## Technical Service Bulletin

### HONDA ACCORD/LEGEND/MDX TIMING COVER MODIFICATION REQUIRED WITH REPLACEMENT OF BELT TENSIONER

Make: Honda  
Model: Accord, Legend, MDX  
Engine: 3.0L, 3.5L & 3.7L  
Year: 2003 - On

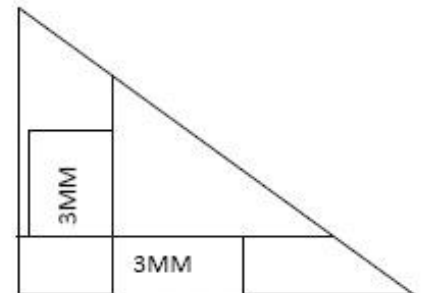
Honda OE now provides an updated tensioner assembly which may cause interference with the front timing cover for some applications. Gates also offers the same updated design as the OE. The update requires that you now remove approximately 3mm of plastic material from the front cover, allowing proper clearance.

Improper clearance may result in a damaged front timing belt cover.

**THIS AREA WILL NEED TO HAVE 3MM OF MATERIAL REMOVED**

The removal of approximately 3mm of plastic material from the lower timing belt cover is recommended prior to the installation of the updated accessory belt drive tensioner, allowing for proper clearance

**IMPROPER INSTALLATION MAY RESULT IN A DAMAGED FRONT TIMING BELT COVER AND IMPROPER ACCESSORY BELT TRACKING, EVENTUALLY LEADING TO BELT FAILURE!**
